Trinity Wharf Development

.....
Further Information Response

Trinity Wharf, Trinity Street, Wexford

Further Information Response

Project Stage	PLANNING						
Project Title	TRINITY WHARF DEVELOPMENT						
Drawing Title	ACCESS ROAD SERVICES PLAN AND SECTION SHEET 2 OF 3						
Drawing Number	TRWH	-	ROD	-	GEN	-	SW_AE - DR - CH - 4068
Scale (A1)	AS SHOWN	Date:	September 2019	Job No:	18.133	Rev:	-

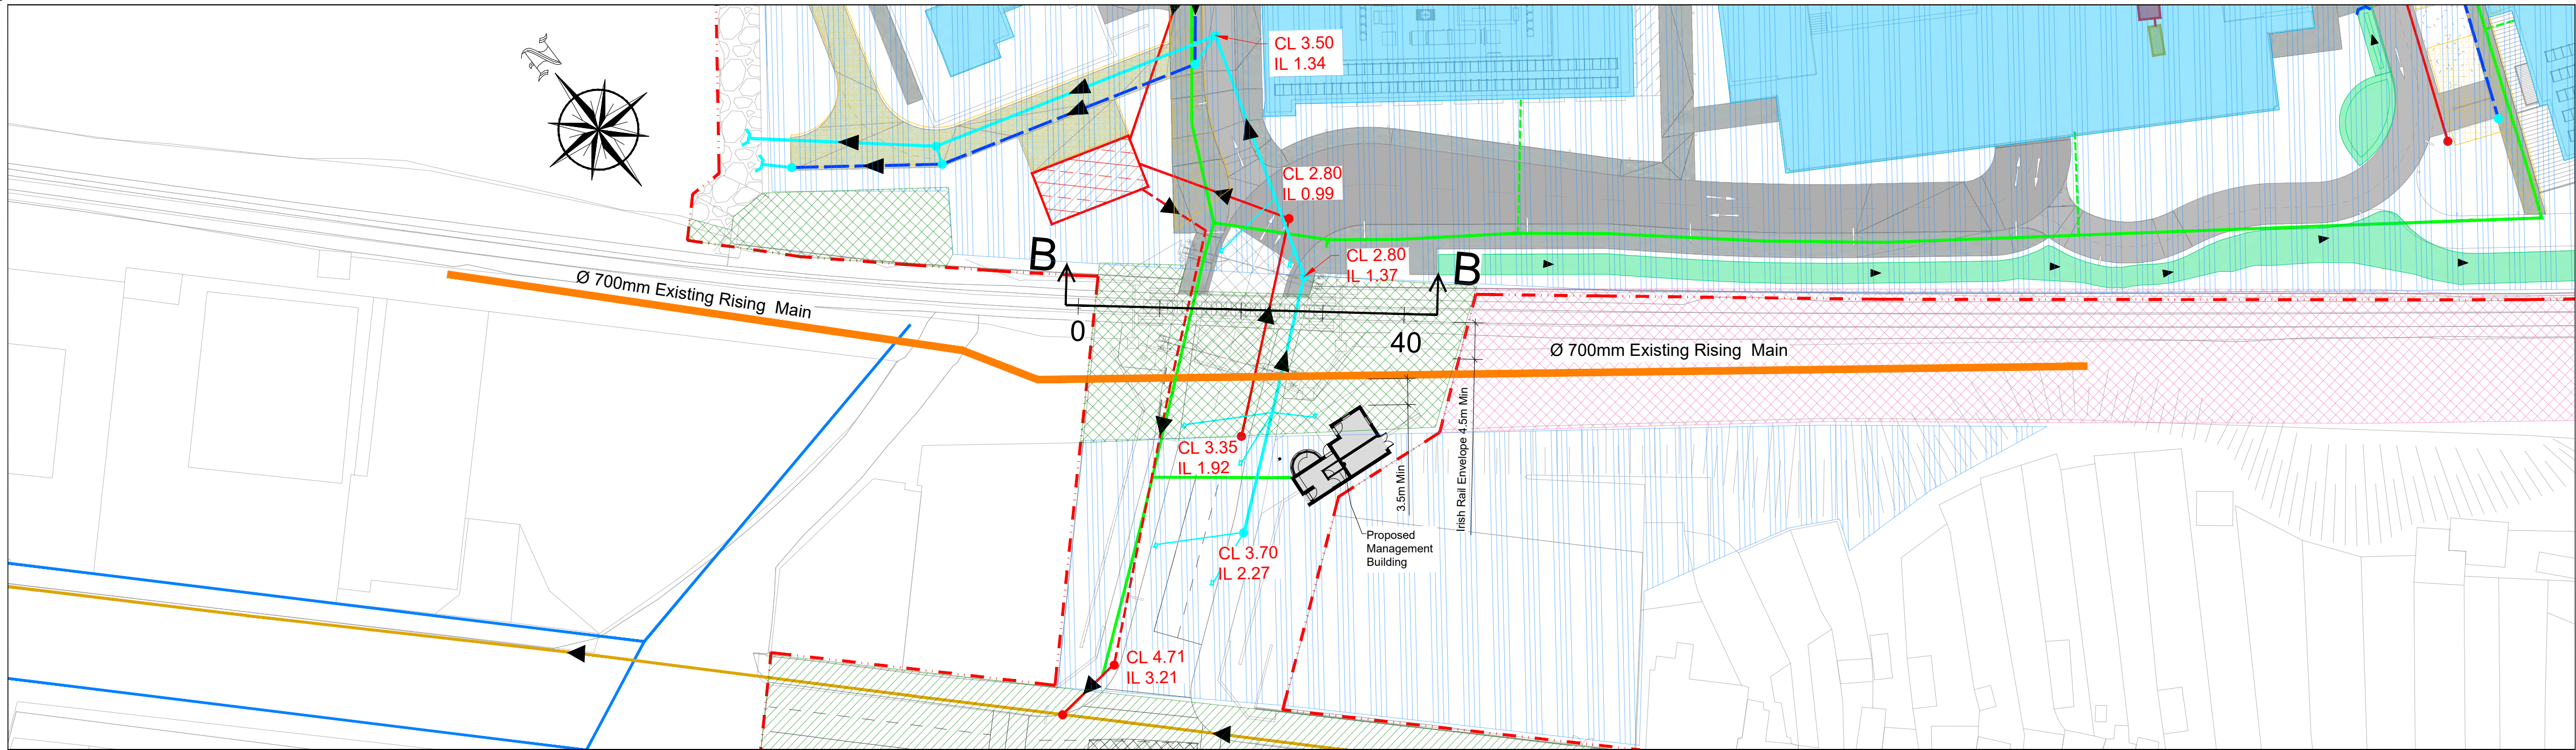
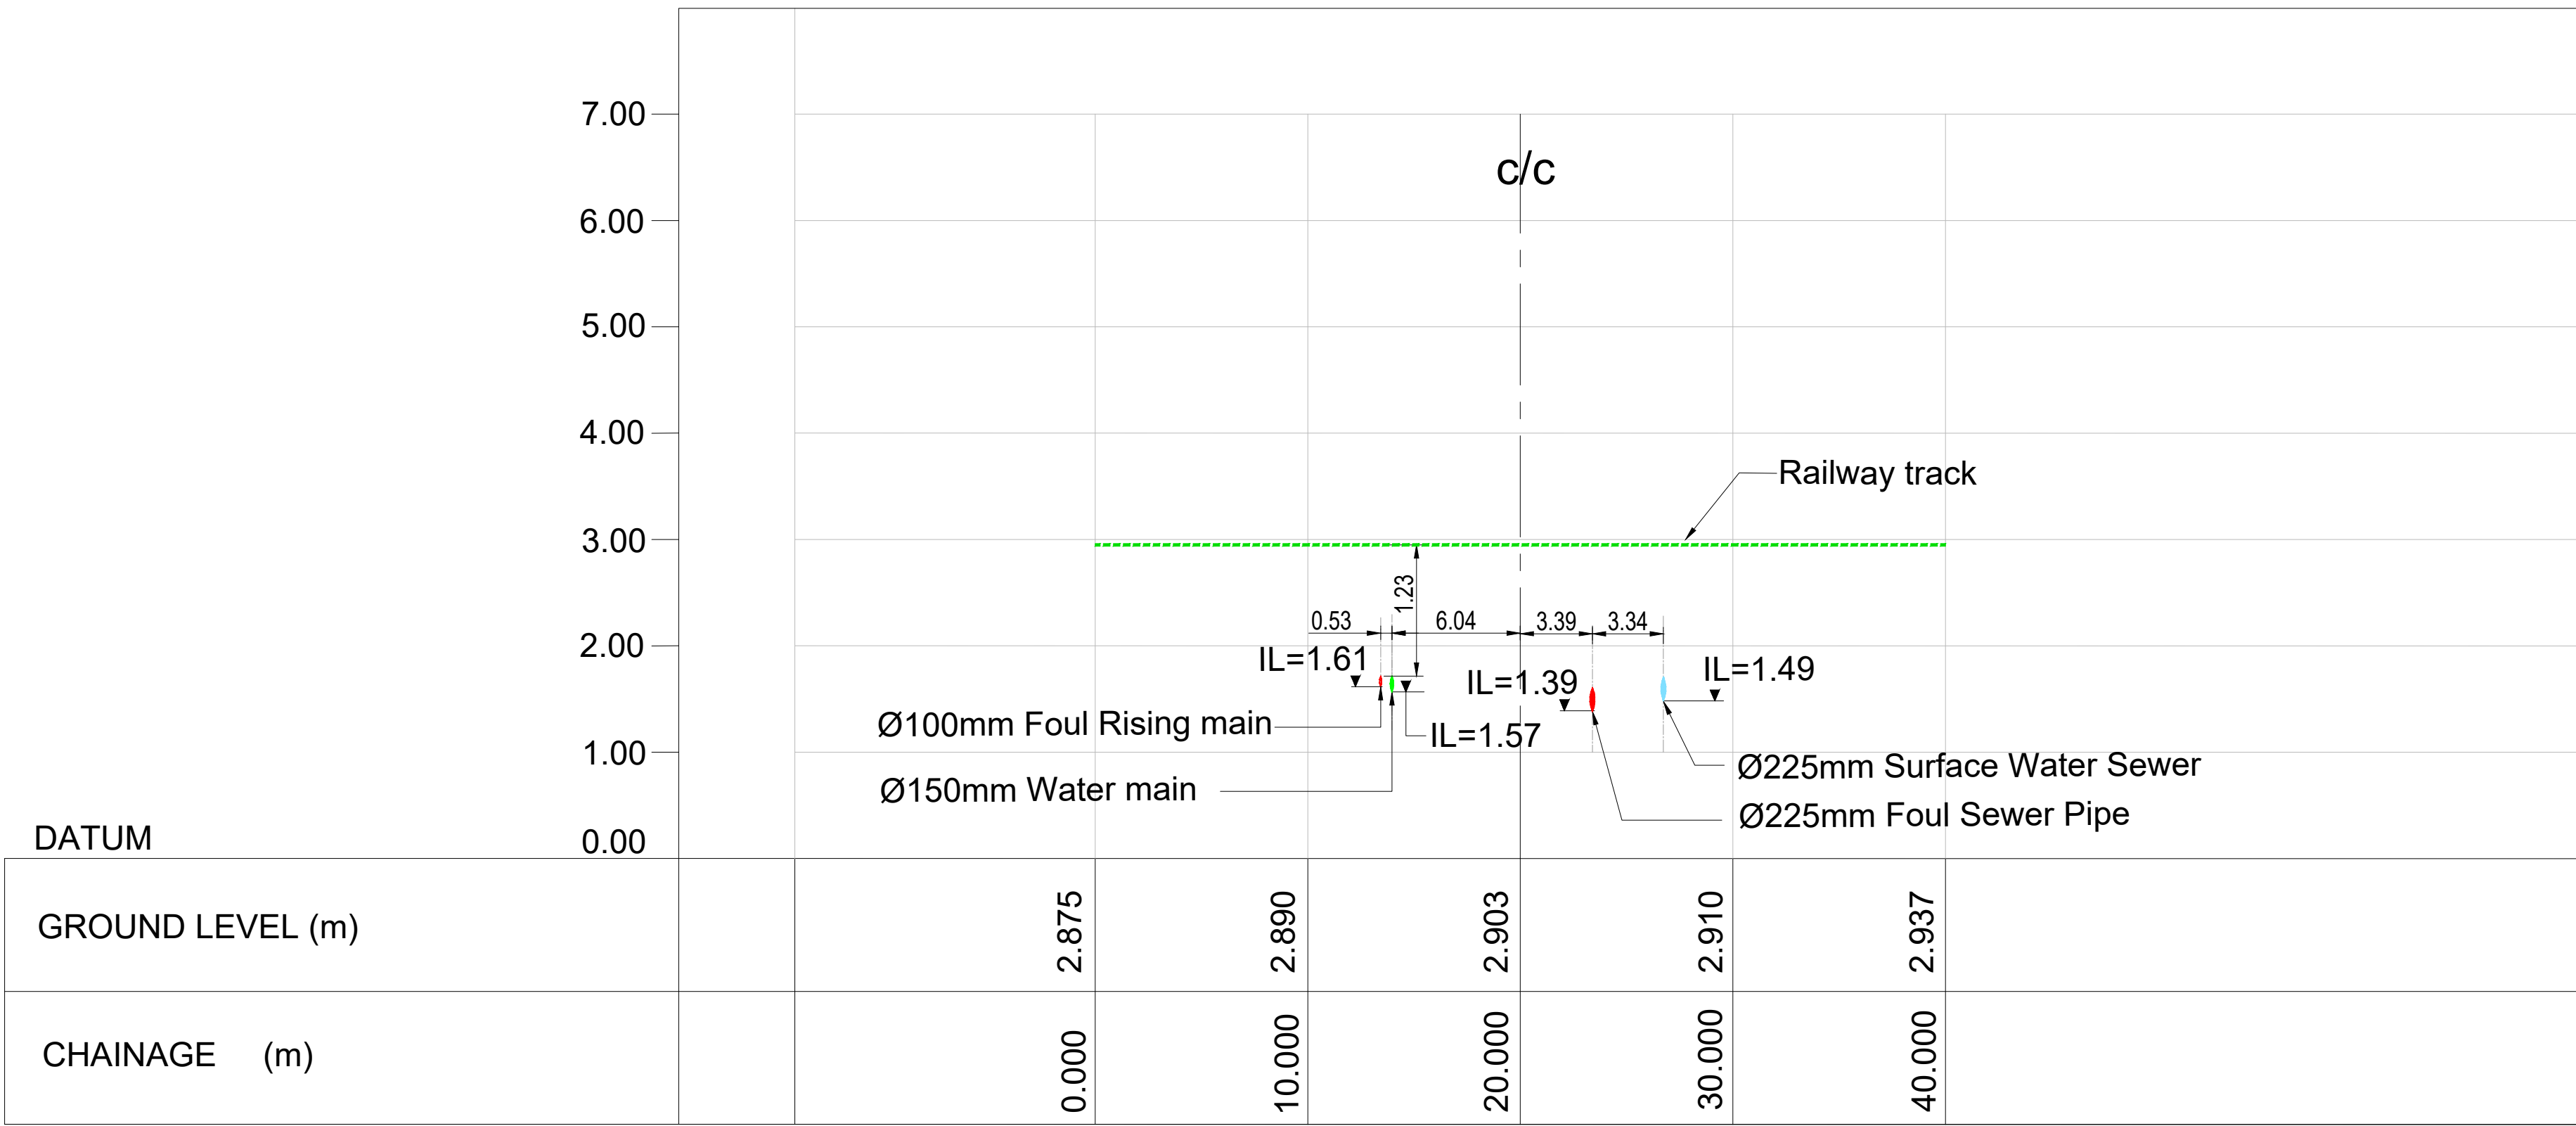
- c. *Please provide a revised long section for the access road which provides information on the location of proposed storm sewers, foul sewers and watermains and how these would interact with the existing railway line and existing rising main.*
